UNITED STATES PATENT AND TRADEMARK OFFICE

APPLICATION NO.	FILING DATE	FIRST NAMED INVENTOR	ATTORNEY DOCKET NO.	CONFIRMATION NO.
09/933,169	08/21/2001	Larry A. Druga	114302.1721	6443

Office Action Summary

DETAILED ACTION

FIG. 2

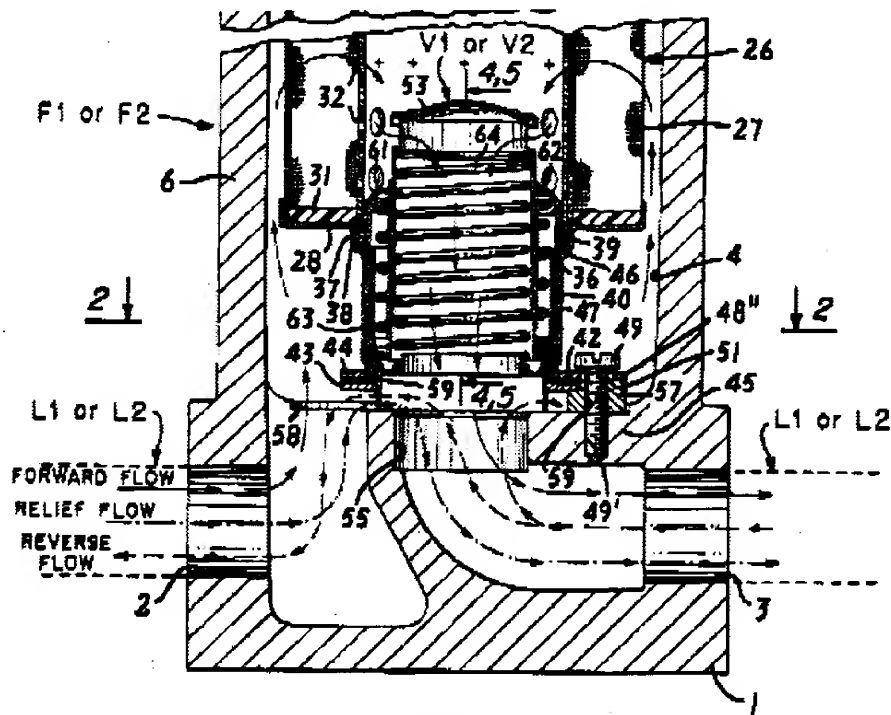
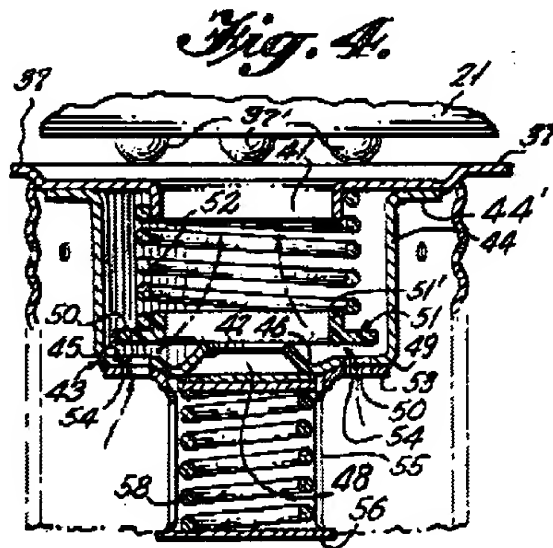
3. Claims 3 and 4 are rejected under 35 U.S.C. 102(b) as being anticipated by Cooper (U.S. 3,996,137). Cooper discloses a fluid filter that clearly anticipates claims 3 and 4. The bottom of figure 2 thereof is reproduced on the next page.

The first, second, third fluid flows and the arrows thereof are shown above as the forward flow, relief flow, and reverse flow, respectively [as in claim 3], wherein the first flow path includes the inlet 2, the space between the filter element 27 and the housing 6, the filter element, a central passage 35, and the outlet 3 [as in claim 4].
